PRODUCT/PROCESS CHANGE NOTICE (PCN)

PCN #: **TB0711-01** DATE: **12/06/2007**
 Product Affected: **950 mils x 950 mils PQFP 132L**
 shipped in tray
 Date Effective: **3/06/2008**

ATTACHMENT I - PCN #: TB0711-01

Existing Shipping Tray

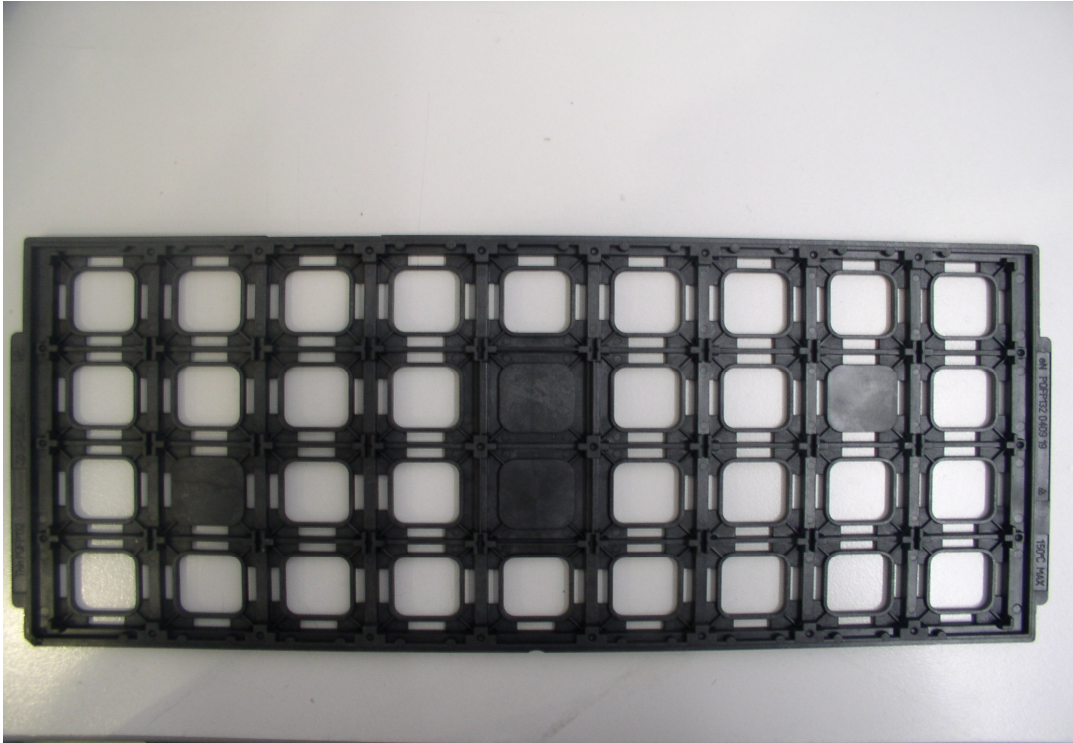
Description	Existing Shipping Tray	New Shipping Tray
Supplier	E-Pak	NK Tech
Supplier Part Number	eN PQFP 132 0409 19	TMHT-040901-01
IDT Part Number	P7-210-000	P7-227-000
Tray Matrix	4 X 9	4 X 9
Qty per Tray	36 units	36 units
Rating Temperature	150°C	135°C
Tray Material	MPPPO	PPE + CF
Pocket Size (WxL)	27.84 X 27.84 +/- 0.13 mm	28.09 X 28.09 +/- 0.13 mm
Tray Drawing Number	MSC-5706	MSC-5755

TOLERANCES UNLESS OTHERWISE SPECIFIED		DECIMALS		ANGLE	
.X ±.25		.XX ±.13		.XXX ±.13	
APPROVALS		DATE		SCALE	
DRAWN		DATE		N/A	
CHECKED		DATE		SIZE	
TITLE:		STOCK NO.		DRAWING NO.	
Pq/PqG 132		P7-227-0001MSC-5755		REV 00	
SHIPPING TRAY		DO NOT SCALE DRAWING		SHEET 1 OF 3

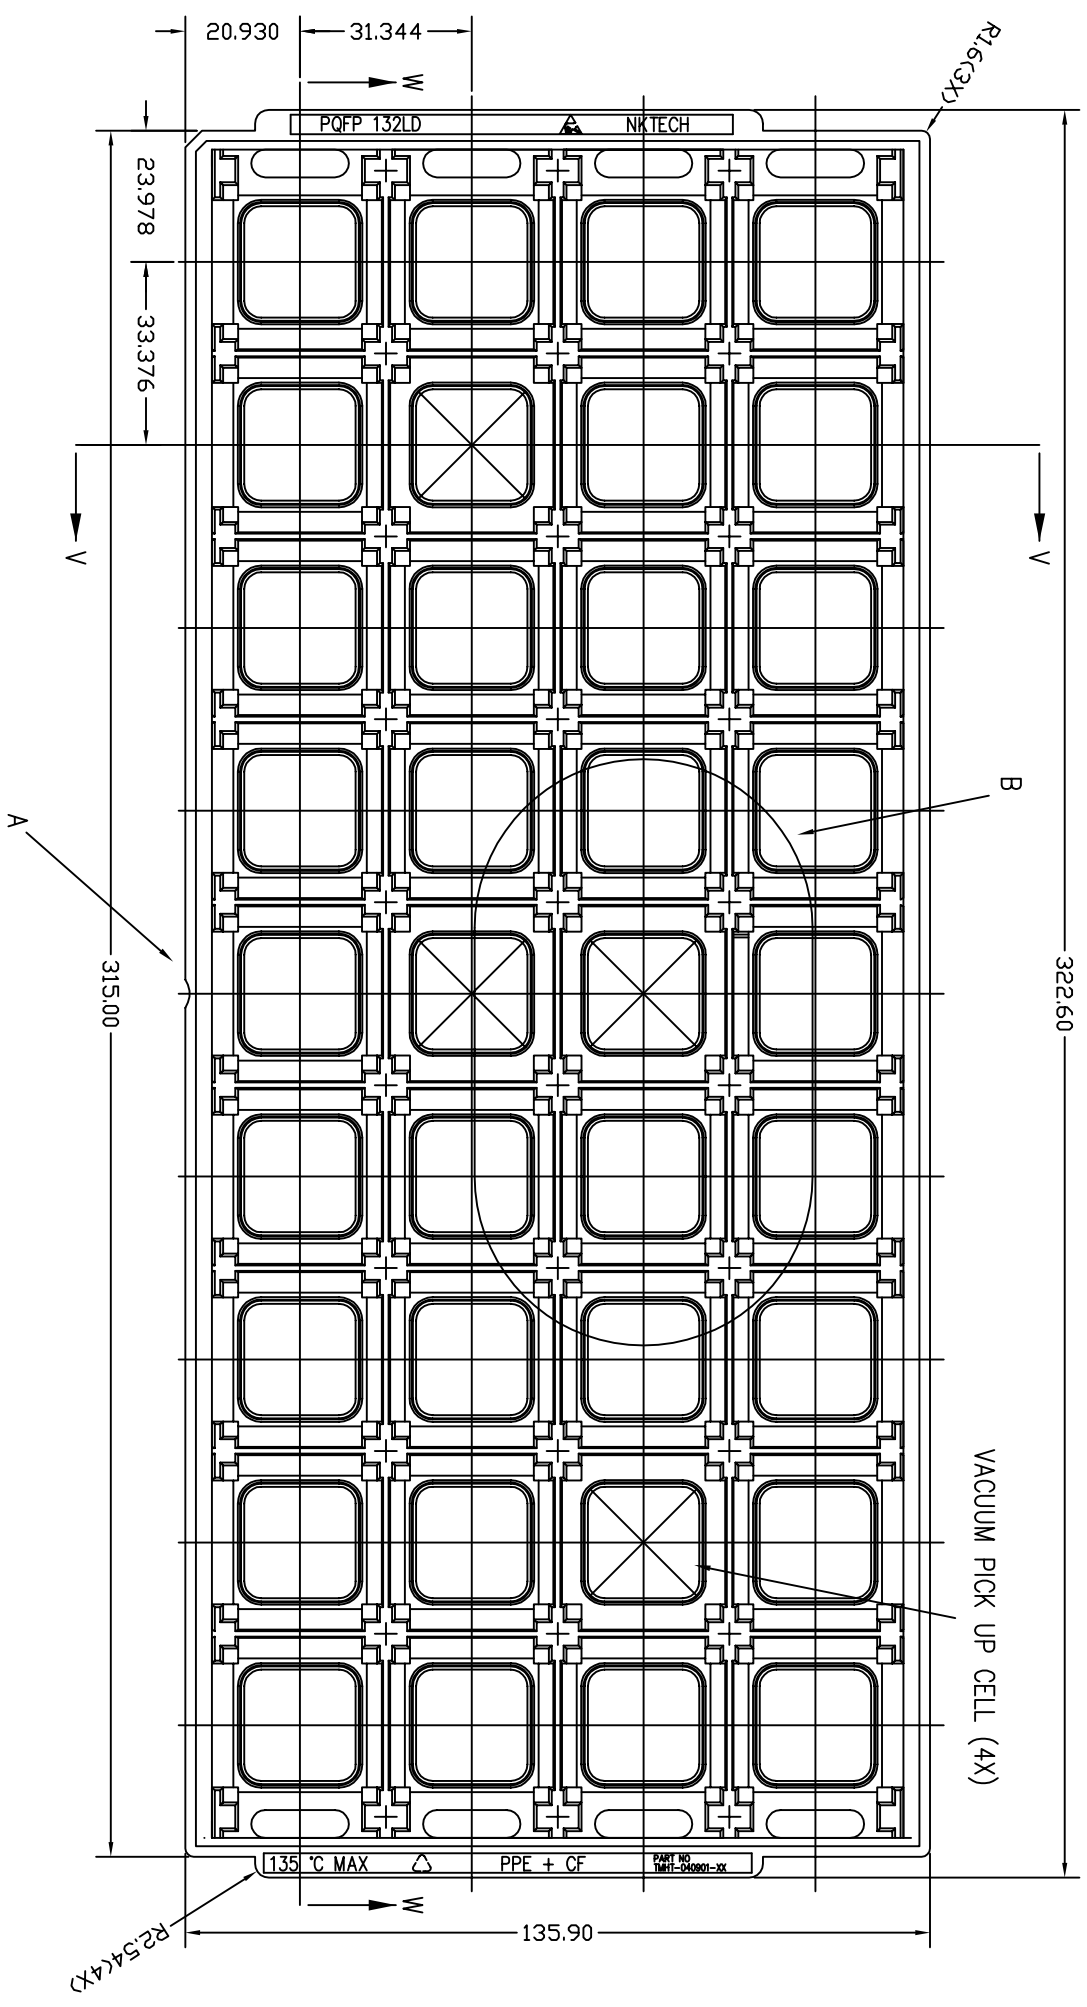
There is no change to the number of units per tray and tray dimensions but changes to the tray withstand temperature.
